Docket No. STN 52-001

Subject: Submittal Supporting Accelerated ABWR Review Schedule - **Effect of  
Changing the Concrete Tensile Strength From 100psi to 10psi**

FIGURE 4-15

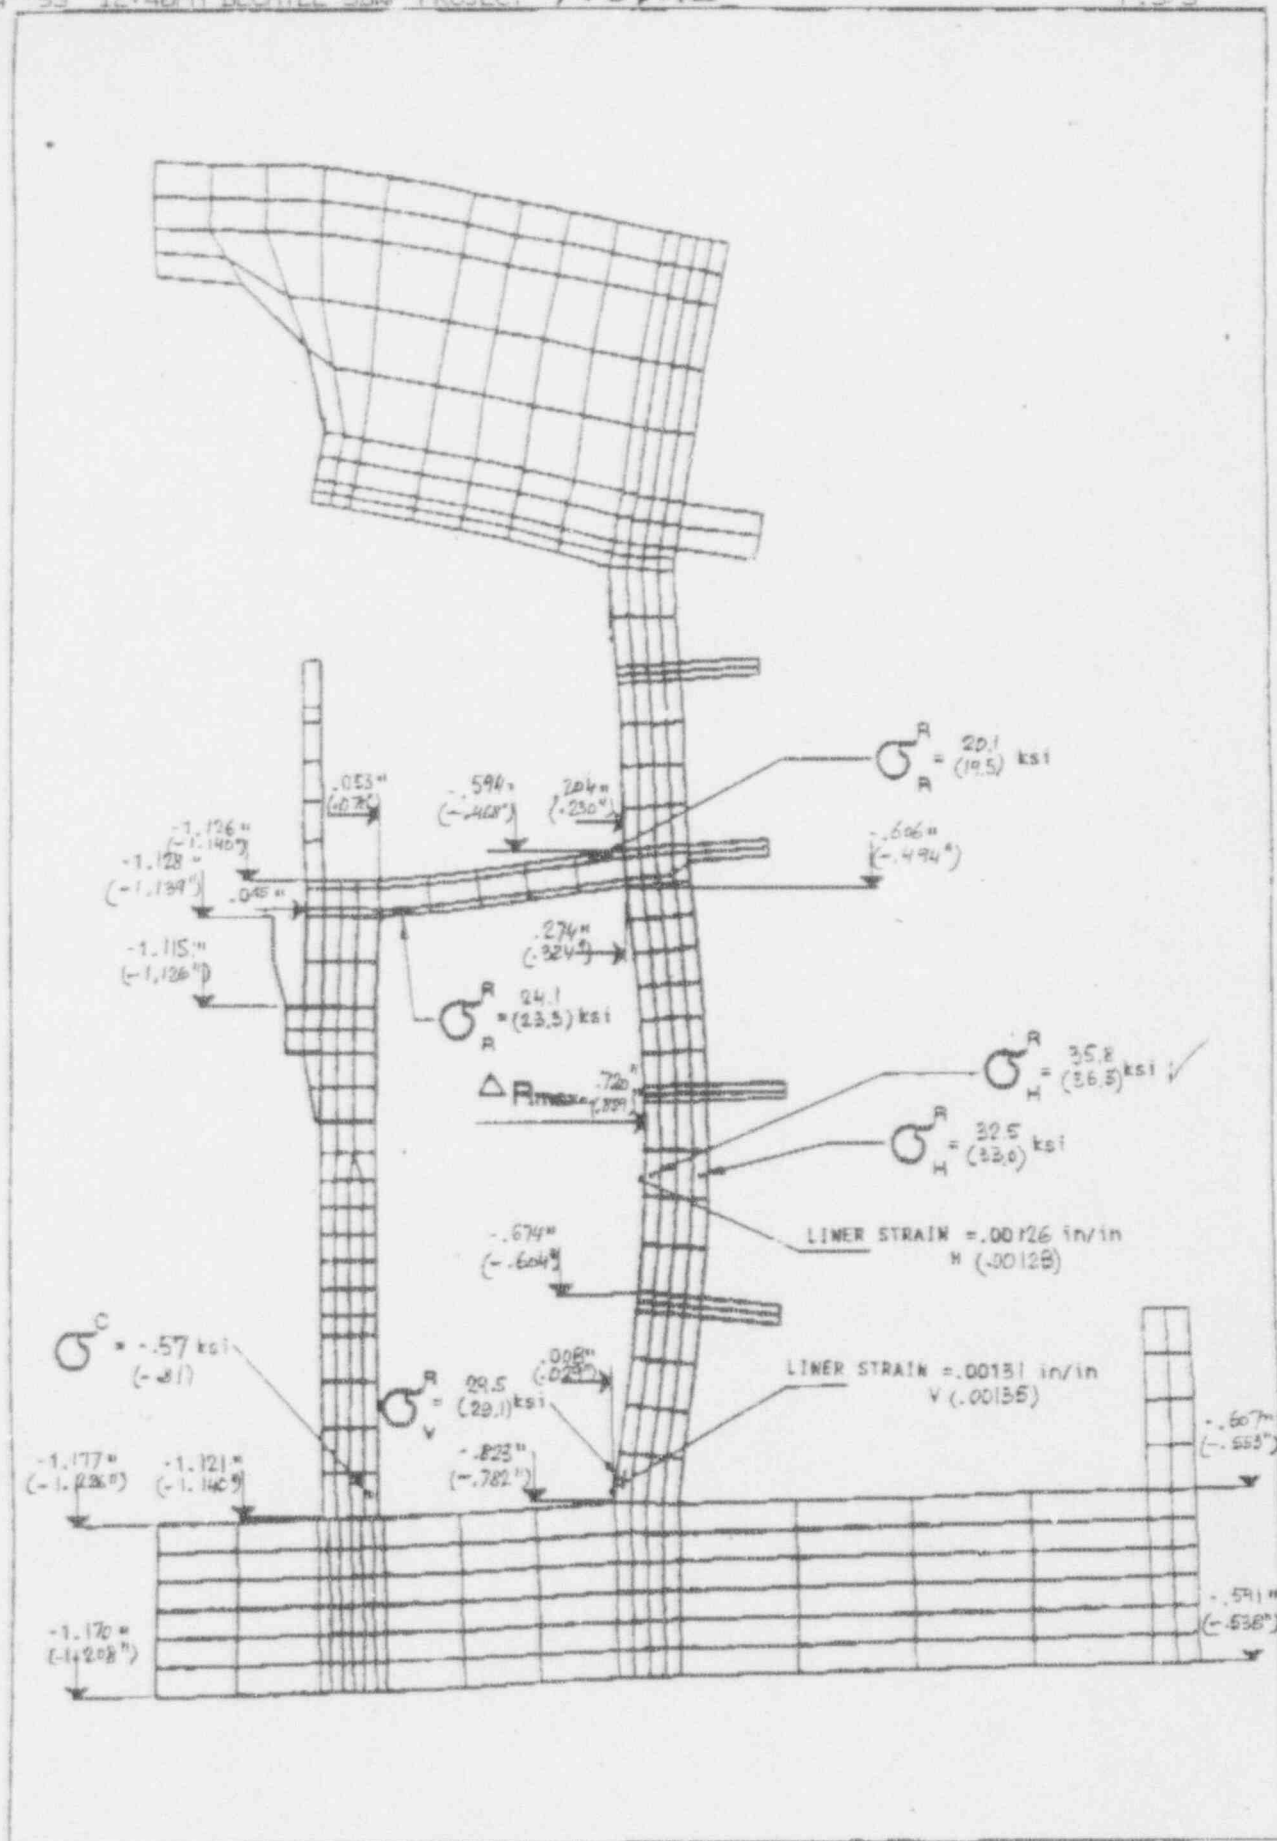
Attached is a comparison of rebar stresses, liner strains, and displacements at 134psi containment pressure plus deadload. It shows no significant change in containment ultimate containment strength. Additional details will be available shortly for your review.
